Office Action Summary

10/672,181

STEIGER ET AL.

DETAILED ACTION

FIG.1B

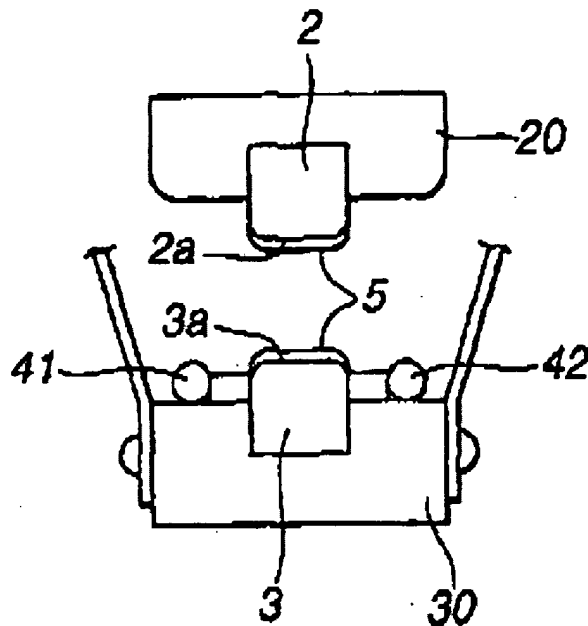
Hori et al illustrates in figure 1B a gas discharge laser having Fluorine gas, column 13 lines 16-20 and having a pair of discharge electrodes (2) and (3) [applicant's lower portion], where each electrode includes a film (5) [applicant's upper curve region] disposed on the discharge parts (2a) and 3(a) [applicant's footprint]. Column 19 lines 11-12, describes the film (5) as an insulator and in column 19 lines 43-46 discloses the

film as a halogen-resistant substance made of copper fluoride [applicant's comprising copper]. In column 19 lines 17-24 Hori discloses, different metals used for the main discharge electrodes, which includes brass [where brass has benefit of applicant's CIP].

However, Ujzdowski et al discloses in column 7 lines 25-29, the use of aluminum bronze as the electrode [applicant's copper alloy].

Therefore, it would have been obvious to a person of ordinary skill in the art at the time of the invention to replace the electrode Ujzdowski et al with the electrode of Hori et al because it is more resistant to fluoride attacks than brass, column 7 lines 25-29 of Ujzdowski et al.

In column 20 lines 5-21 Hori et al discloses a method of bonding the film (5) to the electrodes [applicant's two pieces of material].
